UNITED STATES PATENT AND TRADEMARK OFFICE

APPLICATION NO.	FILING DATE	FIRST NAMED INVENTOR	ATTORNEY DOCKET NO.	CONFIRMATION NO.
10/021,566	12/12/2001	Douglas G. Hunter	DKT 00147A (BW1-00061)	9283

Office Action Summary**Application No.**

DETAILED ACTION

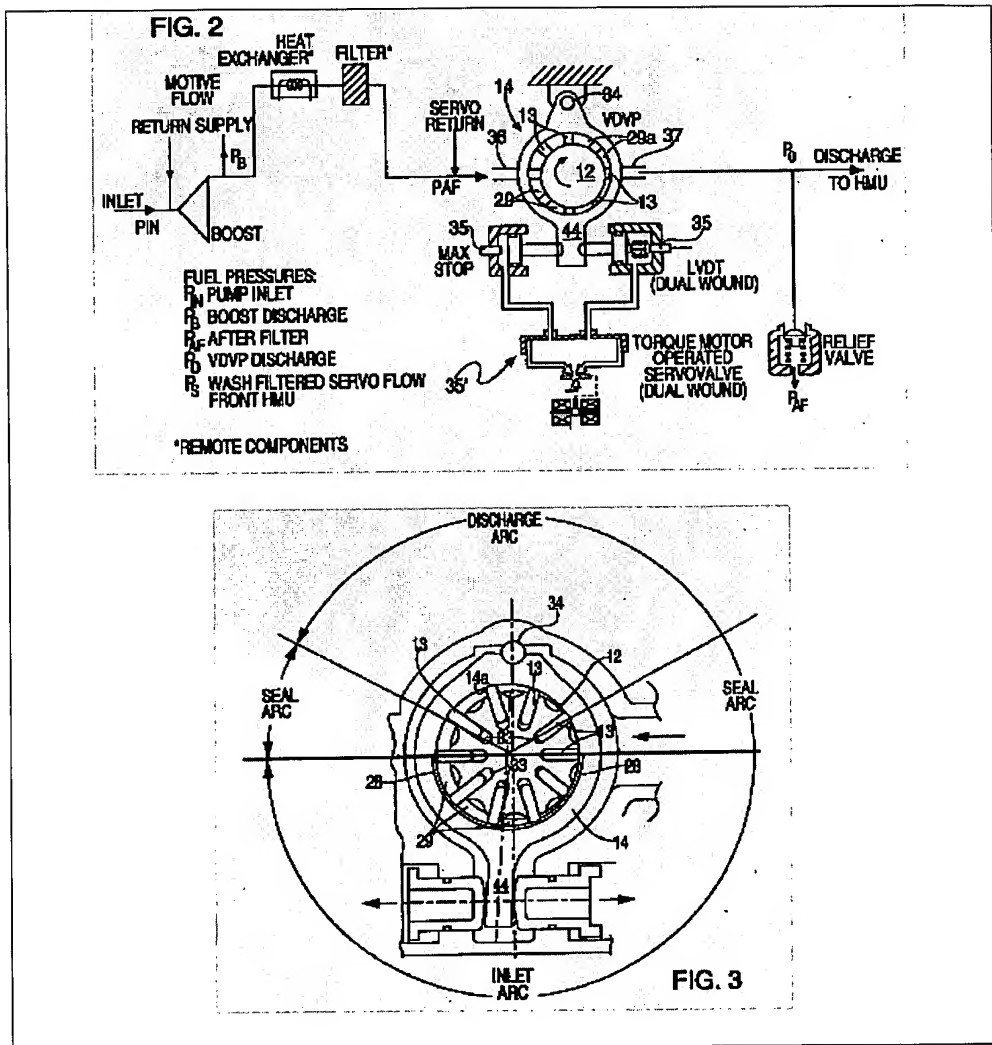
10. **Claims 62-66, 70 & 75** are rejected under 35 U.S.C. 102(b) as being anticipated by (5,545,014) to Sundberg et al.

Sundberg et al., Figures 1-8, in particular Figures 2 & 3 displayed above disclose a variable displacement vane pump (11), comprising: a housing ((19), (20)) defining a

chamber, a pump inlet (36) through which fluid enters the housing {(19), (20)} and a pump outlet (25) through which fluid is discharged from the housing (19) under pressure; a containment ring or eccentric ring (14) pivotally (34) carried by the housing (20) for movement between a first position and a second position and defining an opening {not reference signed} with an internal surface (14a); a rotor (12) carried by the housing {(19), (20)} for rotation relative to the internal surface (14a) and to having a plurality of slots {(31), (33)} extending inwardly into the rotor (12) from an exterior of the rotor; a plurality of vanes (13) carried by the rotor with each vane slidably received in a slot {(31), (33)} in the rotor (12); a first actuator {See Figs. 2 & 3 right-hand piston touching (44)} responsive to application of fluid under pressure in a first actuation pressure signal and operable to pivot the containment ring or eccentric ring (14) in a first direction; and a second actuator {See Figs. 2 & 3 left-hand piston touching (44)} responsive to application of fluid under pressure in a second actuation pressure signal and operable to pivot the containment ring or eccentric ring (14) in a second direction. The first actuator {See Figs. 2 & 3 right-hand piston touching (44)} is a piston slidably carried by the body (20) and responsive to a first actuation pressure signal and the said second direction {See Figs. 2 & 3 at (44)} is in a direction opposite of the first direction. The first actuator {See Figs. 2 & 3 right-hand piston touching (44)} includes a spring {not reference signed} that in yielding biases the containment ring or eccentric ring (14) in said first direction. The pump (11) comprises a pivot pin (34) about which the containment ring or eccentric ring (14) pivots, said pivot pin (34) defining a pivot axis of

the containment ring or eccentric ring (14) which is offset from the axis of the rotor by about one-half the maximum eccentricity of the containment ring or eccentric ring (14) relative to the rotor (12). The slots (33) in the rotor (12) extend radially inwardly on the rotor (12). The said first and second actuators are fluid acting directly (44) on said containment ring (14). See Sundberg et al., Figures 1-8, and respective portions, abstract, col. 5 lines 10-67, col. 6 lines 1-67, col. 7 lines 1-67, col. 8 lines 1-62, of the detailed description.

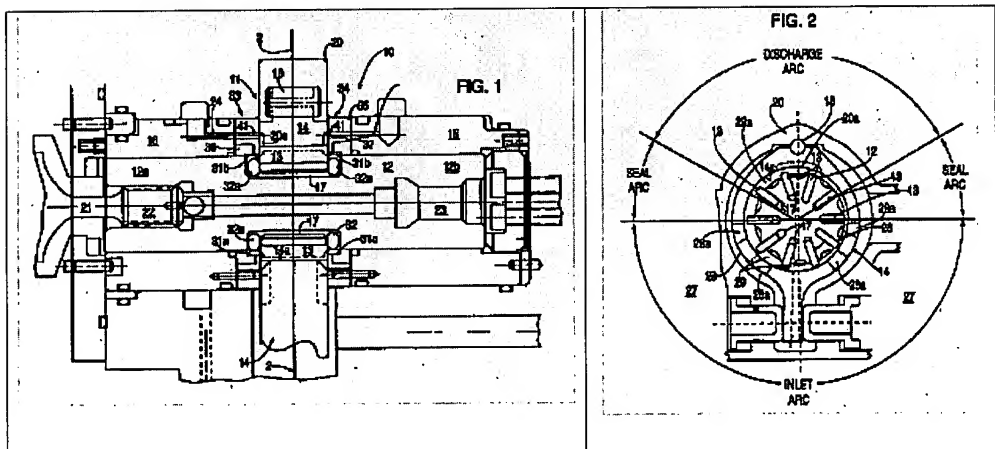
11. Claims 62-65, 70 & 75 are rejected under 35 U.S.C. 102(b) as being anticipated by (5,545,018) to Sundberg.

Sundberg, Figures 1-3, in particular Figures 1 & 2 as immediately displayed above disclose a variable displacement vane pump (11), comprising: a housing (20)

defining a chamber, a pump inlet {not reference signed} through which fluid enters the housing (20) and a pump outlet {not reference signed} through which fluid is discharged from the housing (20) under pressure; a containment ring or eccentric ring (14) pivotally (18) carried by the housing (20) for movement between a first position and a second position and defining an opening {not reference signed} with an internal surface (14a); a rotor (12) carried by the housing (20) for rotation relative to the internal surface (14a) and to having a plurality of slots (17) extending inwardly into the rotor (12) from an exterior of the rotor; a plurality of vanes (13) carried by the rotor with each vane slidably received in a slot (17) in the rotor (12); a first actuator {See Fig. 2 right-hand piston touching (44)} responsive to application of fluid under pressure in a first actuation pressure signal and operable to pivot the containment ring or eccentric ring (14) in a first direction; and a second actuator {See Fig. 2 left-hand piston touching (44)} responsive to application of fluid under pressure in a second actuation pressure signal and operable to pivot the containment ring or eccentric ring (14) in a second direction. The first actuator {See Fig. 2 right-hand piston touching (44)} is a piston slidably carried by the body (20) and responsive to a first actuation pressure signal and the said second direction {See Fig. 2 at (44)} is in a direction opposite of the first direction. The pump (11) also comprises a seal {(33), (34)} between the containment ring or eccentric ring (14) and the housing defining a fluid chamber between the housing {(15), (16), (20)} and containment ring or eccentric ring (14) with fluid under pressure in the fluid chamber defining the first actuator. The slots (17) in the rotor (12) extend radially inwardly on

the rotor (12). The seal {(33), (34)} is carried on the housing {(15), (16), (20)}. The said first and second actuators are fluid acting directly {on the stem handle} on said containment ring (14). See Sundberg, Figures 1-3, and respective portions, abstract, col. 3 lines 60-67, col. 4 lines 1-67, col. 5 lines 1-56, of the detailed description.

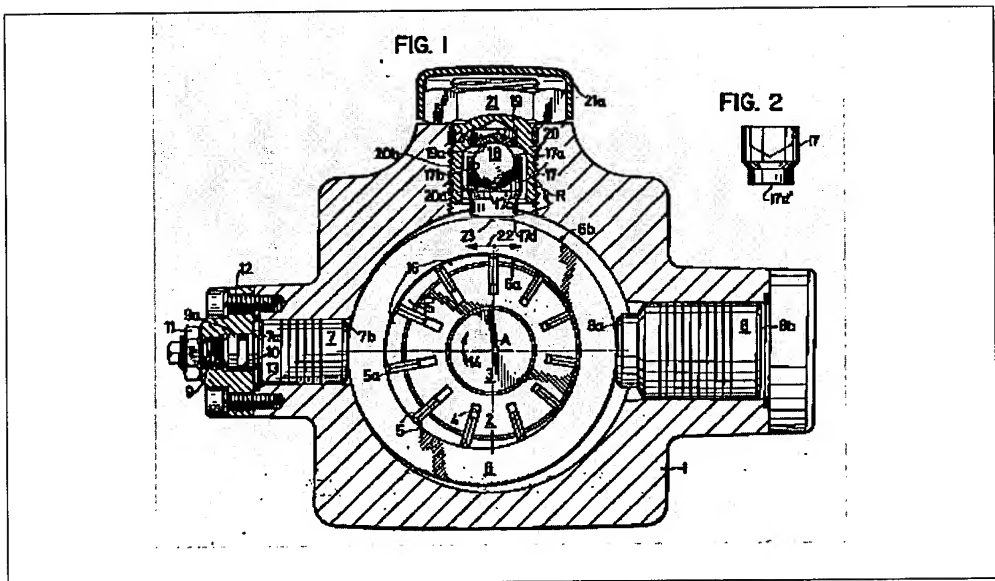
12. Claims 62-65, 70 & 75 are rejected under 35 U.S.C. 102(b) as being anticipated by (3,918,855) to Bornholdt.

Bornholdt, Figure 1 as immediately displayed above discloses a variable displacement vane pump, comprising: a housing (1) defining a chamber, a pump inlet {not reference signed in (1)} through which fluid enters the housing and a pump outlet

{not reference signed in (1)} through which fluid is discharged from the housing under pressure; a containment ring or eccentric ring (6) pivotally (18) carried by the housing (1) for movement between a first position and a second position and defining an opening {not reference signed} with an internal surface (6a); a rotor (2) carried by the housing (1) for rotation relative to the internal surface (6a) and to having a plurality of slots (4) extending inwardly into the rotor (2) from an exterior of the rotor; a plurality of vanes (5) carried by the rotor (2) with each vane (5) slidably received in a slot (4) in the rotor; a first actuator {(7) or (8)} responsive to application of fluid under pressure in a first actuation pressure signal and operable to pivot (18) the containment ring or eccentric ring (6) in a first direction; and a second actuator {(8) or (7)} responsive to application of fluid under pressure in a second actuation pressure signal and operable to pivot the containment ring or eccentric ring (6) in a second direction. The first actuator {(7) or (8)} is a piston slidably carried by the body and responsive to a first actuation pressure signal. The said second direction is in a direction opposite of the first direction. The slots (4) in the rotor (2) extend radially inwardly on the rotor (2). The vanes (5) have leading and trailing faces and the slots (4) in the rotor (2) are slightly wider than the vanes (5) {vanes slide in slots - not an interference fit} so that a fluid film forms {especially after vane wear} between the rotor (2) and the leading and trailing faces of each vane (5). Especially after vane (5) wear against slot (4) a fluid seal is formed by contact between the vane (5) and rotor (2). The said first and second actuators {(7) & (8)} are fluidly acting directly on said containment ring (14). See

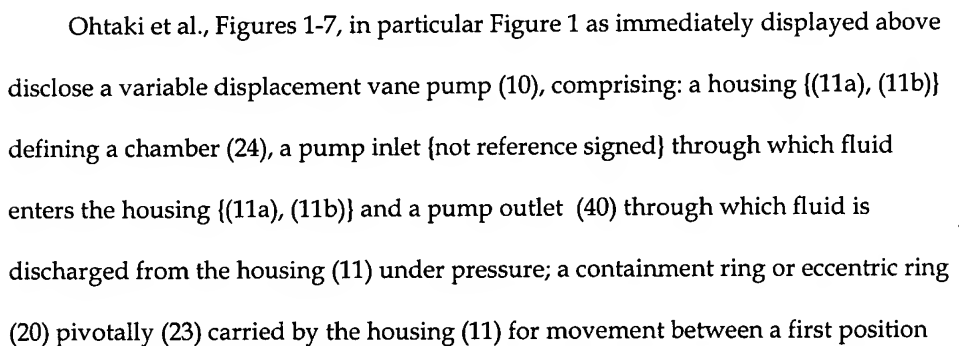
13. **Claims 62-66, 69, 70 & 75** are rejected under 35 U.S.C. 102(b) as being anticipated by (5,141,418) to Ohtaki et al.

and a second position and defining an opening {not reference signed} with an internal surface (21); a rotor (14) carried by the housing {(11a), (11b)} for rotation relative to the internal surface (21) and to having a plurality of slots {(16), (17)} extending inwardly into the rotor (14) from an exterior of the rotor; a plurality of vanes (15) carried by the rotor (14) with each vane slidably received in a slot {(16), (17)} in the rotor (14); a first actuator {Right-hand piston (33) touching (22)} responsive to application of fluid under pressure and operable to pivot the containment ring or eccentric ring (20) in a first direction; and a second actuator {Left -hand piston (37) touching (22)} responsive to application of fluid under pressure and operable to pivot the containment ring or eccentric ring (20) in a second direction. The first actuator {Right-hand piston (33) touching (22)} is a piston slidably carried by the body (11) and responsive to a first actuation pressure signal {in (43)} and the said second direction {See (22)} is in a direction opposite of the first direction. The second actuator is a piston (37) slidably carried by the body (11) and responsive to a second actuation pressure signal {in (41)}. The first actuator {Right-hand piston (33) touching (22)} includes a spring (34) that in yielding biases the containment ring or eccentric ring (22) in said first direction. The pump (11) comprises a pivot pin (23) about which the containment ring or eccentric ring (20) pivots, said pivot pin (23) defining a pivot axis of the containment ring or eccentric ring (20) which is offset from the axis of the rotor by about one-half the maximum eccentricity of the containment ring or eccentric ring (20) relative to the rotor (14). The slots in the rotor {(16), (17)} extend radially inwardly on the rotor (14).

The said first and second actuators are fluid acting directly (22) on said containment ring {(20), (22)}. A {passive} control {restricting} valve (45) is responsive to a first fluid pressure signal {in (41) and a second fluid pressure signal {in (43)}. See Ohtaki et al, Figures 1-7, and respective portions, abstract, col. 2 lines 35-68, cols. 3 & 4 lines 1-68, of the detailed description.

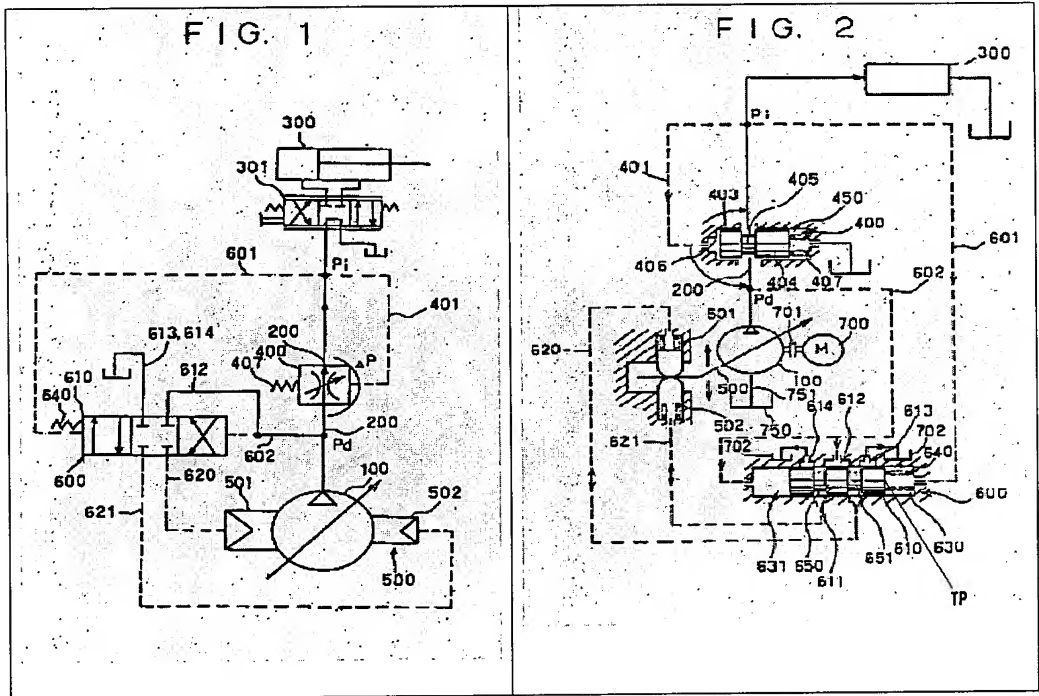
Iwata et al. Figures 1 & 2 as immediately displayed above disclose a variable displacement pump (100) containing a first actuator (501) responsive to application of fluid pressure [in (620)] and a second actuator responsive (502) responsive to application of fluid under pressure [in (621)] wherein control and positioning of the first (501) and second actuators (502) are a function of a first feedback {fluid, pressure} signal (Pd) and a second feedback {fluid, pressure} signal (Pi) taken from discrete locations

separated by a degree of inherent hydraulic resistance in a downstream fluid circuit {in line (200)}. Iwata et al. also discloses a compression spring (640) connected to a first end (601) of the flow control valve (600). The second end of the spring (604) is connected to a target piston (TP).

Iwata et al. does not disclose the variable displacement pump to be a rotary vane pump. See Iwata et al. Figures 1-5 and respective portions, abstract, and remaining disclosure.

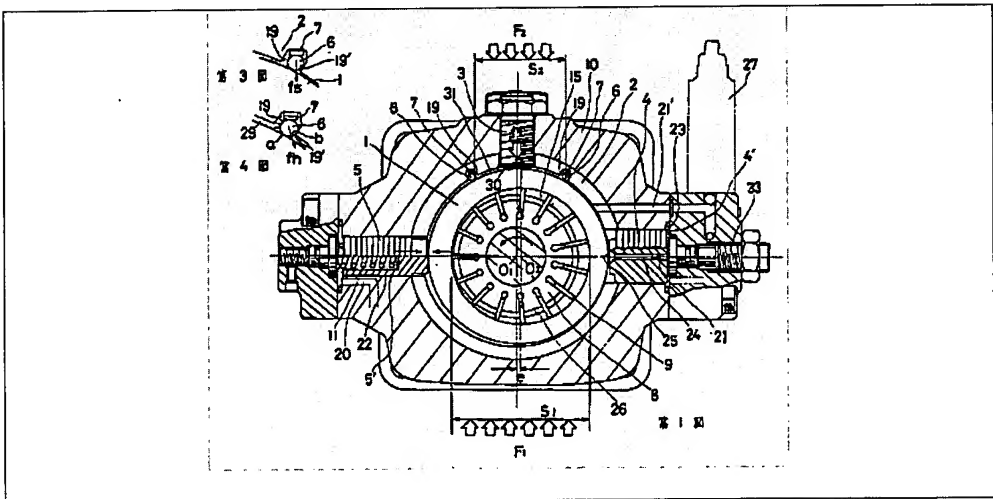
Takagi et al. Figures 1, 3 & 4 as immediately displayed above disclose a rotary vane pump with first fluid actuator (4) and second fluid actuator (5) with seal(s) (6),

rotor (8), vanes (9). First and second fluid chambers defined between first and second fluid actuators and seals (6). See Takagi et al. Figures 1-4 and English abstract.

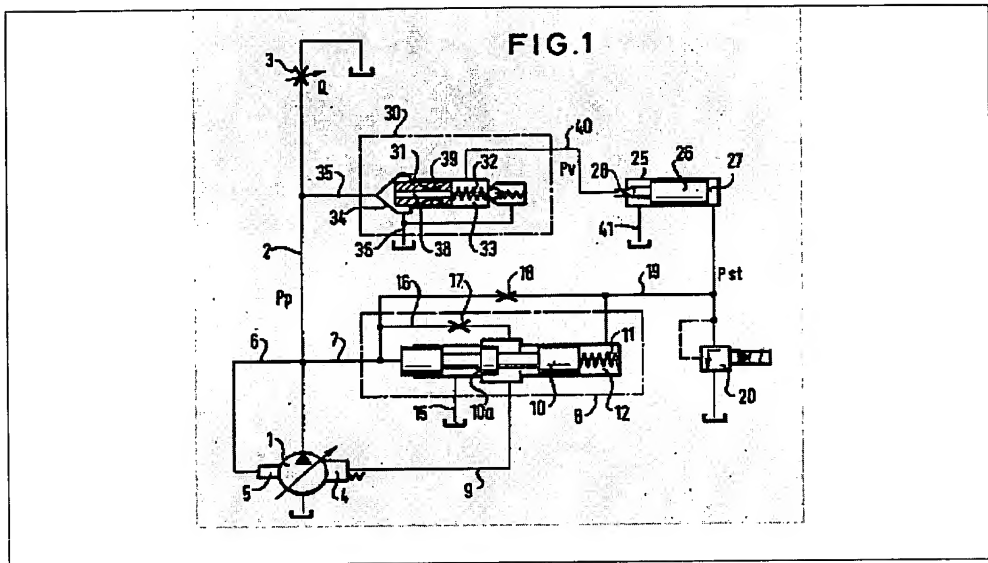
Dantlgraber, Figures 1 as immediately displayed above discloses a pressure control valve (8) responsive to a first pilot pressure {via (19)} to control application of said first fluid pressure to said first actuator (4), and responsive to a second pilot pressure {via (7) & (16)} to control application of said second fluid pressure to said second actuator (5). Dantlgraber also discloses a control circuit that can be responsive to engine conditions {Load (3)} for providing a variable targeting of pump output {abstract - low and high pressure ranges of a variable displacement pump} wherein pressure from the oil circuit in the engine {Load (3)} acts on the first actuator (4) and pressure from the outlet acts {via (6)} on the second actuator (5) for variable control of the eccentric ring {in (1)} in response to these conditions. The pump comprises an

exhaust {discharge} opening {connected to (2)}. See Dantlgraber, Figures 1-3, and respective portions, abstract, col. 2 lines 40-68, col. 3 lines 1-68, col. 4 lines 1-28, of the detailed description.

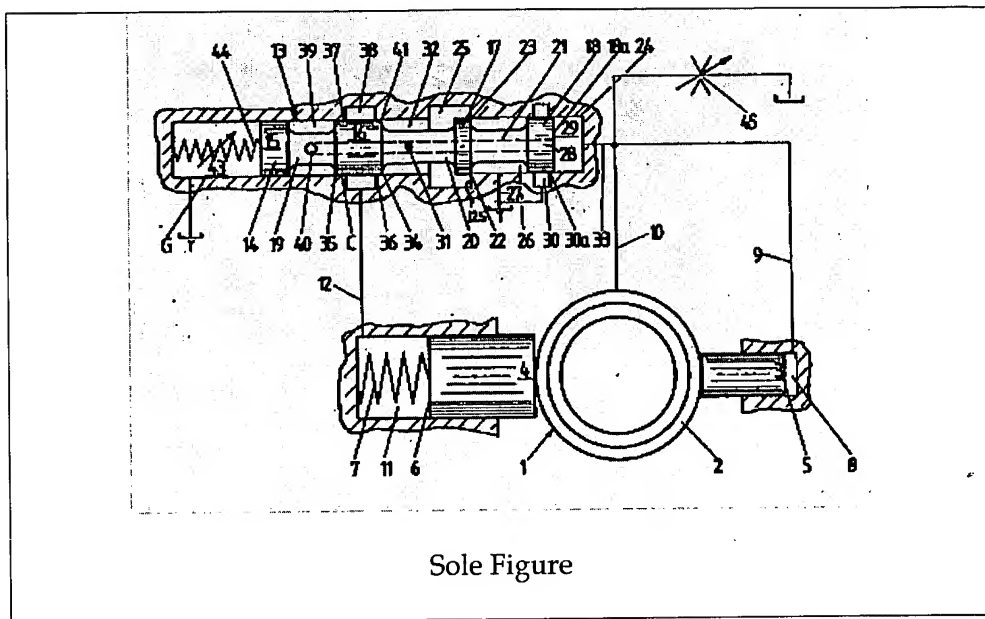
Fischer et al., sole Figure as immediately displayed above discloses a pressure control valve (13) responsive to a first pilot pressure {via (33)} to control application of said first fluid pressure to said first actuator (4), and responsive to a second pilot pressure {via (12)} to control application of said second fluid pressure to said second actuator (3). Fisher et al. also discloses a control circuit that can be responsive to engine conditions {Load (45)} for providing a variable targeting of pump output {abstract - adjustment means for changing the output volume of fluid pump} wherein pressure from the oil circuit in the engine {Load (45)} acts on the first actuator (4) and pressure from the outlet acts {via (9)} on the second actuator (3) for variable control of the

eccentric ring (2) in response to these conditions. The pump comprises an exhaust {discharge} opening {connected to (10)}. See Fischer et al., sole Figure, and respective portions, abstract, col. 3 lines 15-68, cols. 4 & 5 lines 1-68, col. 6 lines 1-6, of the detailed description.

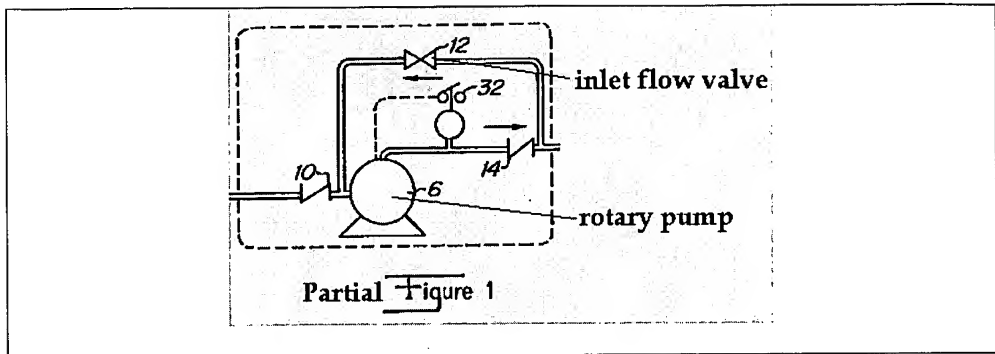
Hancock et al. Partial Figure 1 as immediately displayed above discloses an inlet flow valve (12) which is spring loaded biased to a position preventing fluid discharge from the pump outlet to flow into the inlet of the pump and responds to a threshold fluid pressure in the discharge line to allow fluid from the pump discharge outlet to flow into the pump inlet. See Hancock et al. Figure 1 and respective portion col. 6 lines 5-28 of the detailed description.

It would have been obvious at the time the invention was made to take the invention of Iwata et al in view of Ohtaki et al. and place an inlet flow valve between (Pd) and line (751) so as to provide self-priming to rotary pump (100) so as to provide cavitation and rotor burn-out.
